APPLICATION NO.	FILING DATE	FIRST NAMED INVENTOR	ATTORNEY DOCKET NO.	CONFIRMATION NO.
10/634,287	08/05/2003	Timothy W. Crockett	RPS9-2002-0138US1	7985
45219	7590	03/30/2006	EXAMINER	
KUNZLER & ASSOCIATES 8 EAST BROADWAY SUITE 600 SALT LAKE CITY, UT 84111			NGUYEN, JIMMY H	
			ART UNIT	PAPER NUMBER
			2629

Office Action Summary

Replacement Sheet
 Title: **KEY CODE FILTER APPARATUS AND METHOD**
 Inventors: Crockett et al.
 Docket No.: 1300.2.16 / RPS9-2002-0138 (JBS)
 Page 1 of 8

Fig. 1A

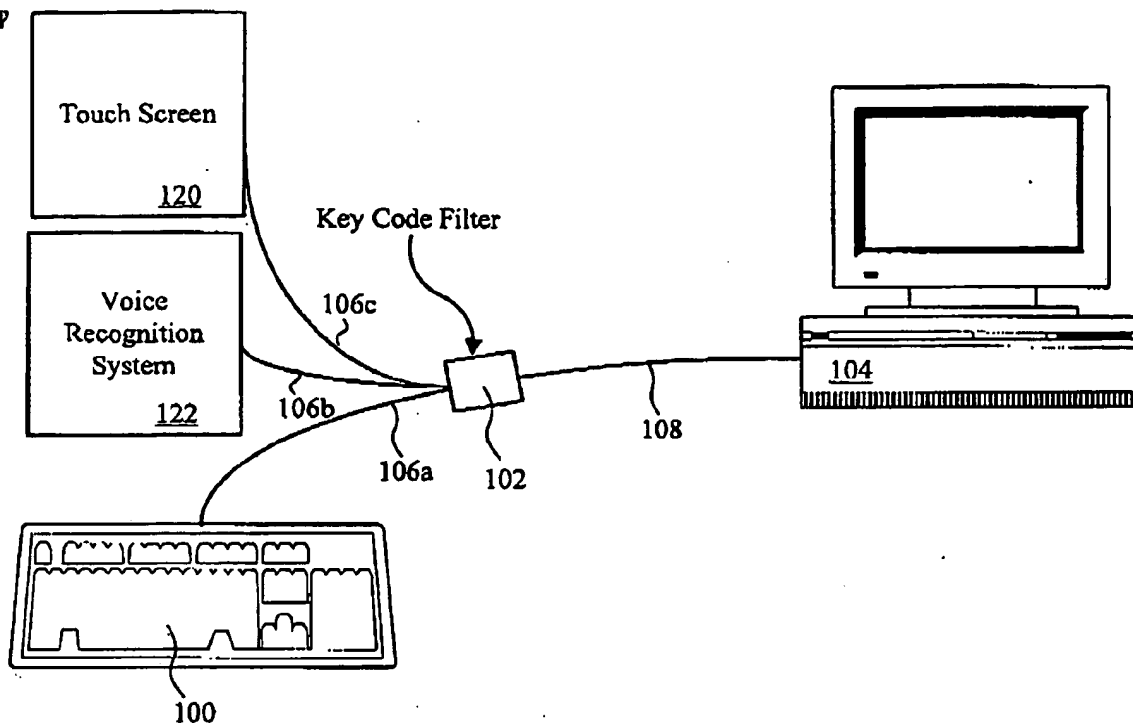
4. The drawing was received on 01/04/2006. This drawing is disapproved because it introduces new matter into the disclosure. The original disclosure does not disclose the key code Filter 102 simultaneously connected to a keyboard 100, a touch screen 120, a voice recognition system 122, and a host computer 104, as shown in the submitted drawing.

6. The drawings are objected to under 37 CFR 1.83(a). The drawings must show every feature of the invention specified in the claims. Therefore, the features, "a touch screen" of claim 28 and "a voice recognition system" of claim 30, must be shown or the feature(s) canceled from the claim(s). No new matter should be entered.

NOT APPROVED
 J.A.N.
 3/16/06

Fig. 1B

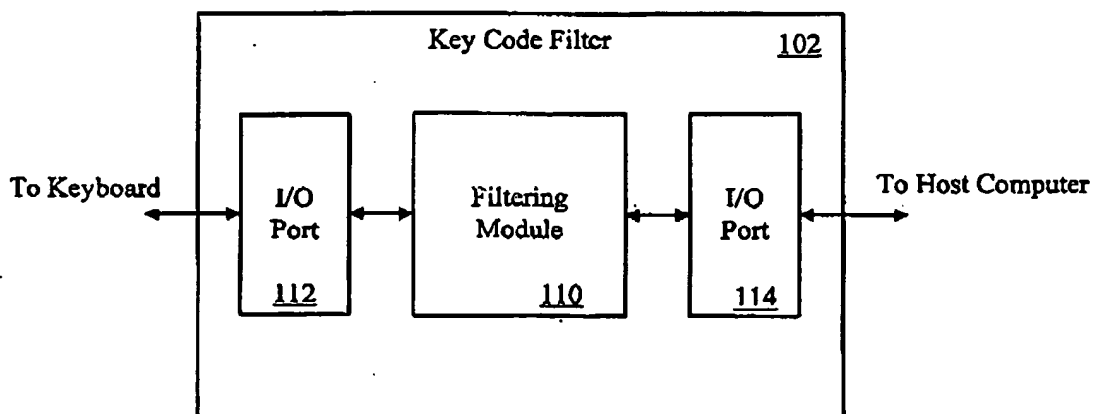
5. The drawings are objected to because "Filtering Module 110" as shown in Fig. 1B and "Filter Module 300" as shown in Fig. 3 are clearly distinct from each other, but are named

similarly. Further, as noting in Figs. 1B, 2 and 3, the Filtering Module 10 is a hardware and comprises elements (210, 216, 222, 224 and 226) (see Fig. 2) including a memory 216 which includes a Filter Module 300 (see Fig. 3). Also, a Filter Module 300 of the memory is not a hardware and a merely virtual portion of the memory and a module is usually referred as a packaged functional assembly of electronics components for use with other such assemblies (see Merriam Webster's Collegiate Dictionary, tenth edition). Therefore, it is suggested a Filter Module 300 should be named differently from the Filtering Module 100, e.g., Filtering Code, Filtering Subroutine, or etc..

17. Claims 1-11 recite the limitation "the unblocked key codes" in last line of independent claim 1. There is insufficient antecedent basis for this limitation in the claim. Additionally, it is not clear the claimed limitation, "a filtering module" recited in line 5 of independent claim 1, corresponding to a Filter Module 100 as shown in Fig. 1B or a Filter Module 300 as shown in Fig. 3.
